MEMORANDUM

Title: Notes on As-Built Pin Valving for the HEPI Actuator
Refer to: LIGO-T040078-02
Date: 30 April 2004
Author: Dennis Coyne

Figure 2: Actuation Plate Hole Dimensions (D020285-A with Revision B markups indicated)

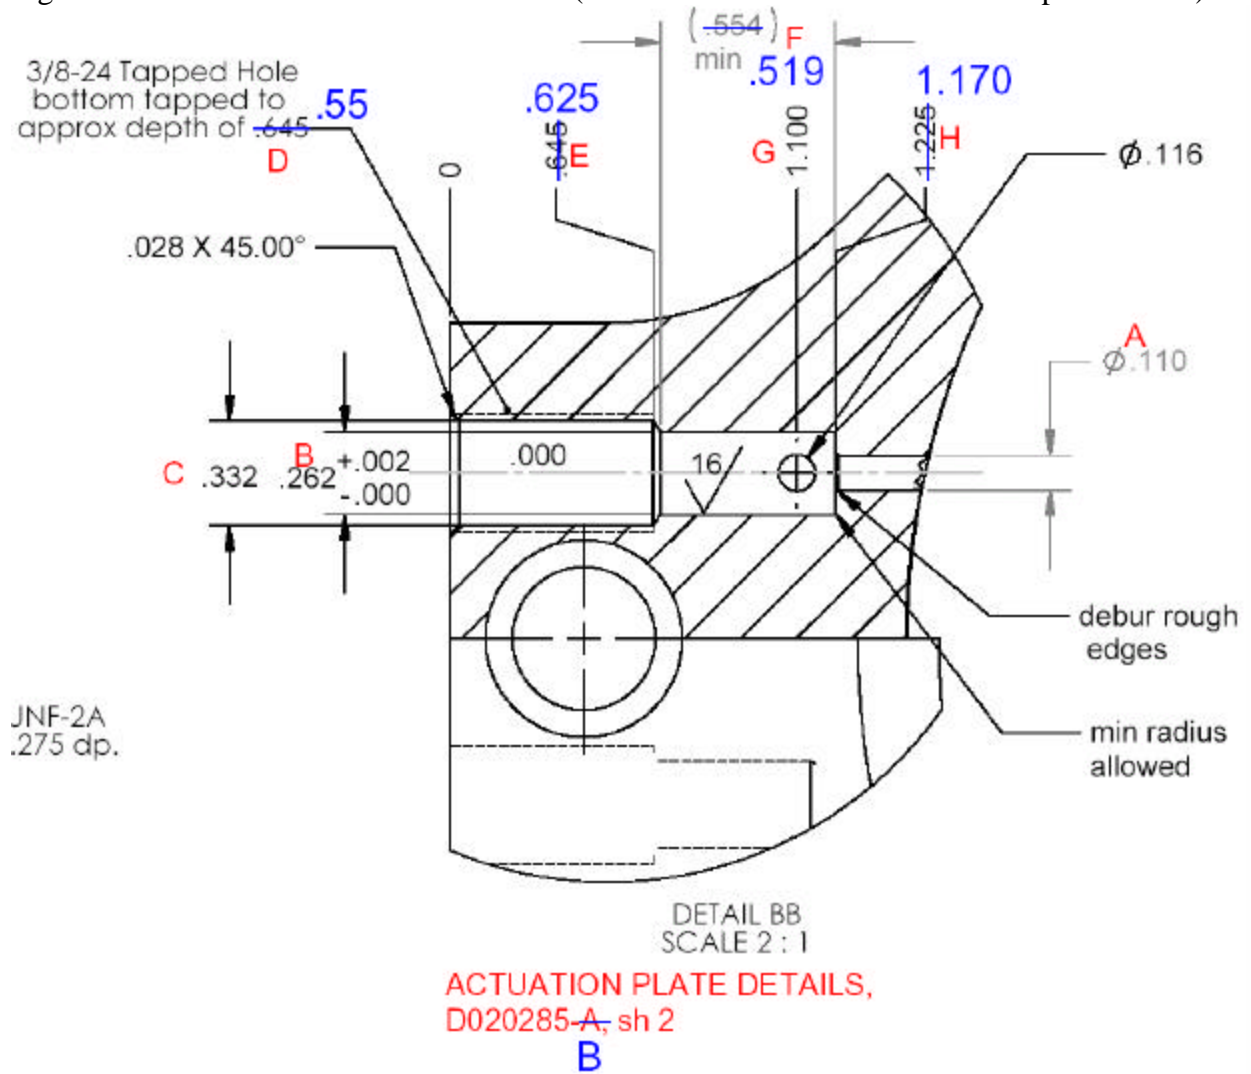
On several of the holes burrs were observed at the side port near the bottom of the small pin valve bore hole. While these burrs may not impede the small pin valve from seating they represent a small risk of migration and blockage.

The bottom of the pin valve bore (nominal 0.262" diameter), which forms the sealing edge (with the nominal 0.110 through hole orifice), has significant chatter in many of the actuator plate holes. This makes the sealing edge serrated. While this may prevent a perfect seal, it is deemed acceptable since small leakage (weeping) past the pin valves in actuator run mode is acceptable.

- 0) Check all bores and remove side port burrs and metal chips.
- 1) Modify the existing pins as follows (revision D¹, see figure 4):
 - a) reduce the threaded region length by 0.053" (from 0.168" to 0.115") by lathing off about 1.5 thread, thereby increasing the piston length. This will leave 2.5 threads remaining.
 - b) lathe down the thread major diameter to 0.363" (from 0.373"). This is the minimum diameter for a 3/8 – 24 UNF thread.

Figure 3: Small Pin Dimensions (D020359-B, sh 1) [Initial Production Revision]

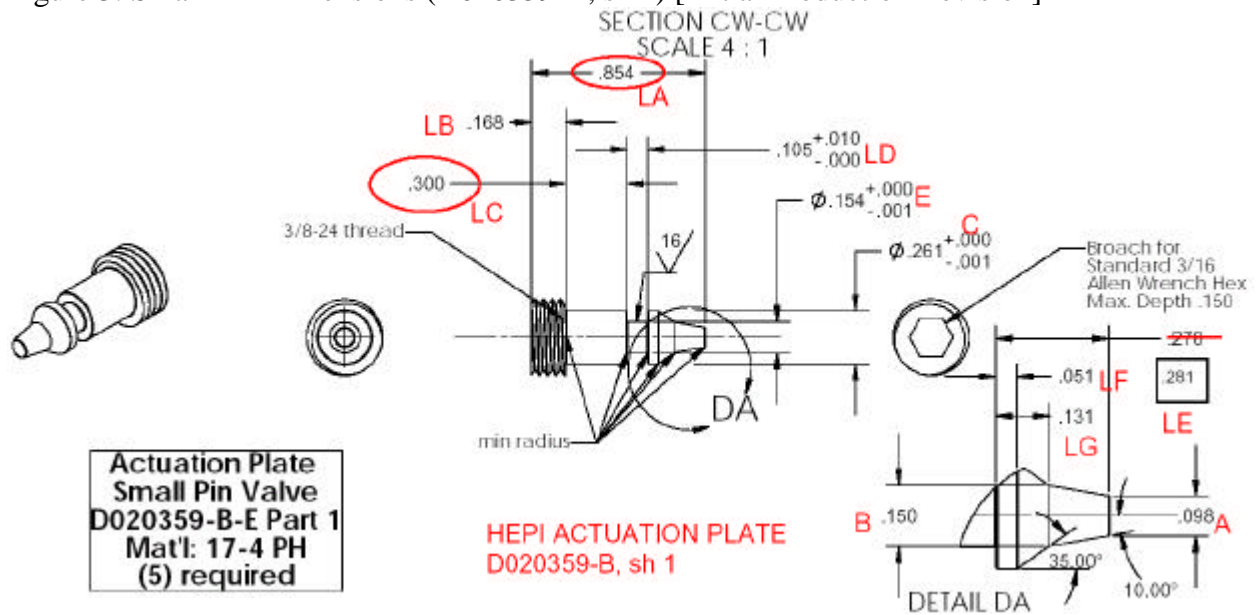
The small pins do not properly seat against their conical tips. This is based on two observations:

The manufacturer for the machined parts of the actuator was supposed to confirm that the pin valves seated properly (using marker on the conical tip), but failed to catch this problem. The problem is basically a design problem with too little tolerance allowed for thread depth (nominal dimensions work with a 0.031" tolerance). While a minimum length of the o-ring bore length (nominal 0.262" dia.) was specified, an equally important maximum length (or conversely minimum thread depth) was not specified. The marker test that the pin valves seat properly should have caught this problem when the parts were inspected and before welding into the actuator assembly.

Figure 4: Small Pin Dimensions (D020359-C, sh 1) [Revision used for the X-end Station actuators]

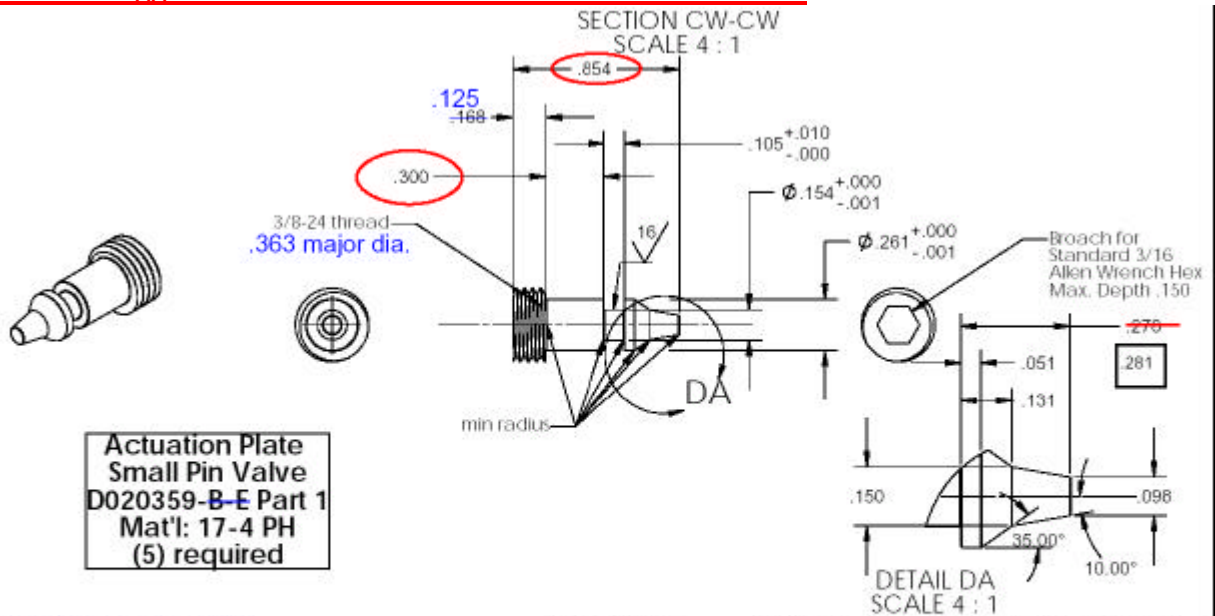
REVISION C 4/27/2004
 REDUCED THREAD LENGTH AND
 MAJOR DIAMETER TO FIT SHORT
 DEPTH THREAD IN ACTUATOR PLATE,
 D020285
